Goose & MLA Project Sites – 2025 Annual Geotechnical Inspection

Back River Project, Nunavut, Canada
B2Gold Back River Corp.

SRK Consulting (Canada) Inc. ■ CAPR004312 ■ March 2026

G-199: Differential settlement of northernmost seacan in Sandvik laydown area

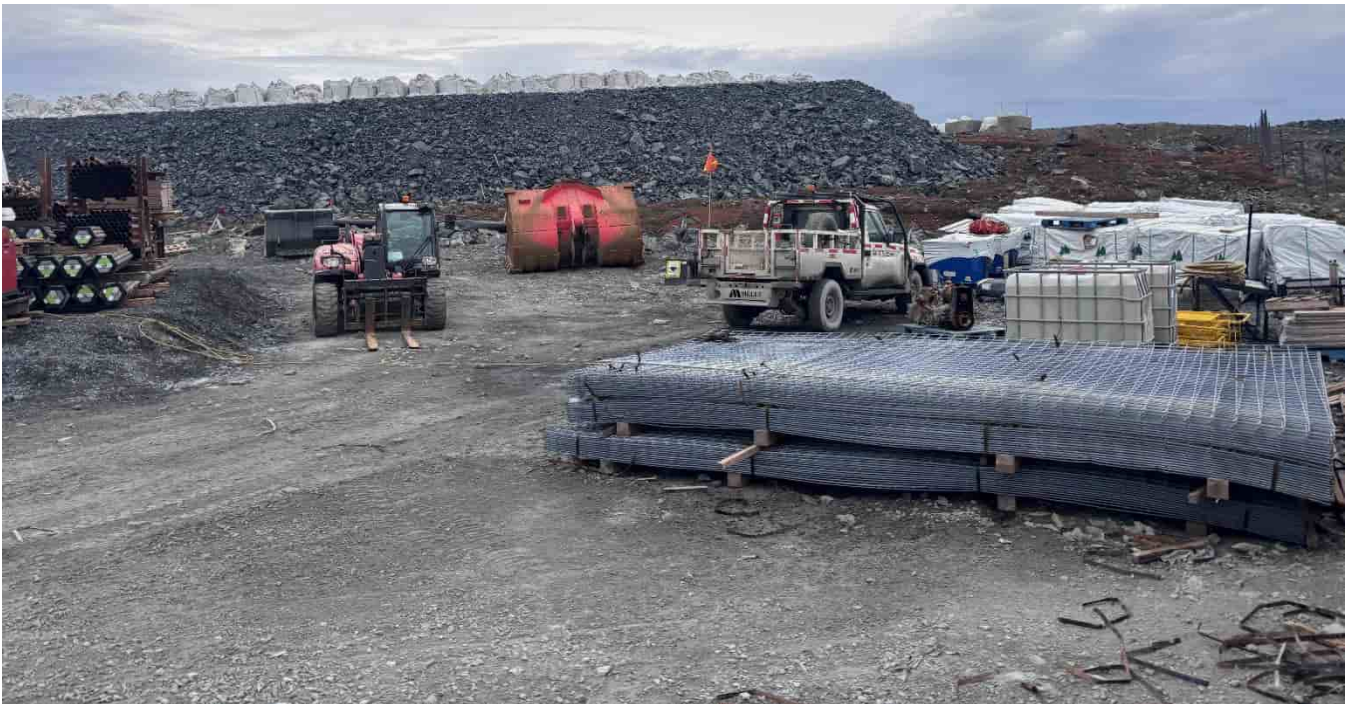
G-198: Slope beside laydown, facing W – Note differential settlement of northernmost seacan
